Volume 5, Number 4

Supplemental Addendum

Attached to and a part of Chicago Cubs "Triple Play" (Game#696)

Incorporating Field Conversion Kit MA768

FIGURE 1.

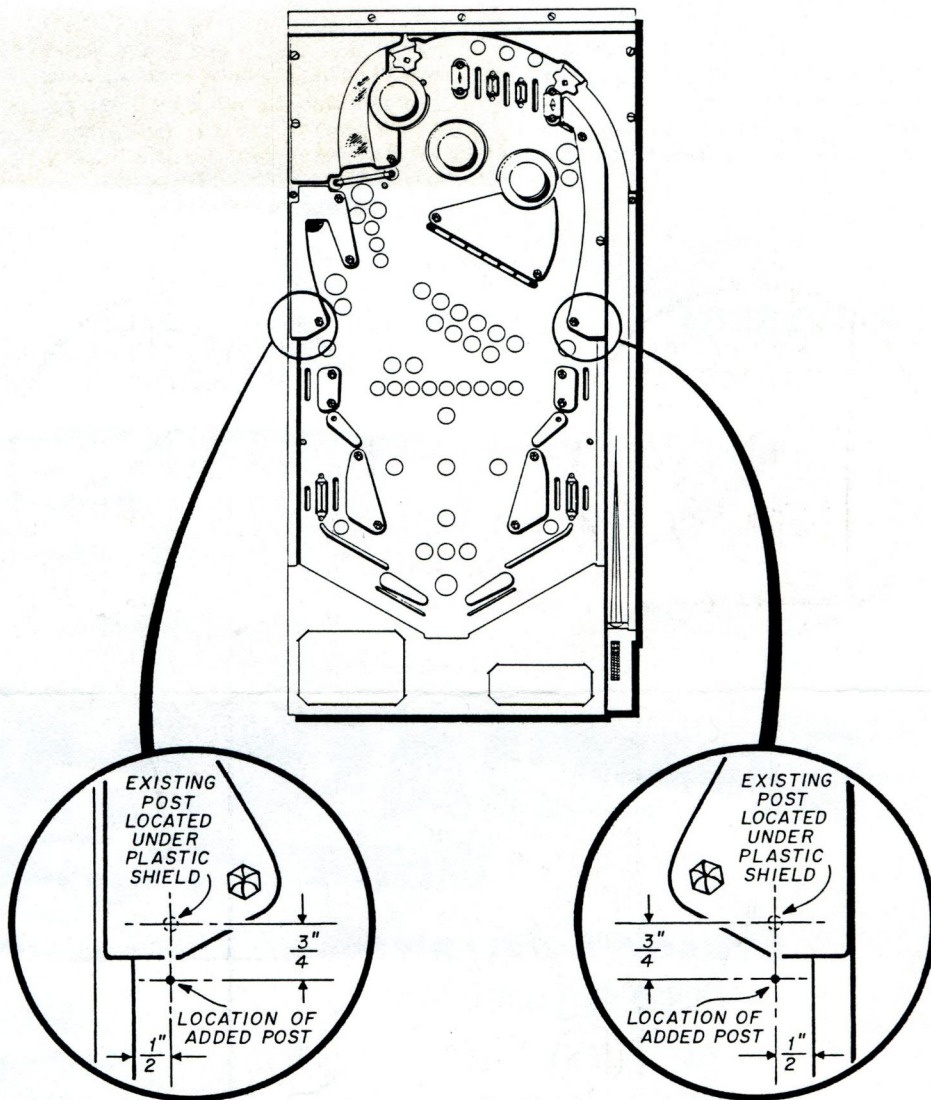
- A. The game prom change and switch 8 usage allows a player to complete more innings, thus accumulating more bonus.
- B. The addition of the two posts adds more game play time. (See figure 1).

Add

Item	Description	Part No.
1.	1" Plastic Post (2)	11561P
2.	Rubber Ring 5/16" (2)	10217
3.	Screw, #6x1-1/2 RHSMS (2)	FA278
4.	Washer, #6 (2)	FA615

5. Remove the cabinet glass and set aside. Using figure 1 as a guide, measure the 3/4" location from the post and 1/2" from the wood rails and center punch. Using a #42 drill (.093), drill a 1/4" deep pilot hole on the left and right sides. Do not drill thru the playboard. Remove the wood chips.

Insert the screws and washers into the plastic posts and tighten securely and perpendicular to the playboard. Add the rubber rings and replace the cabinet glass to the game.
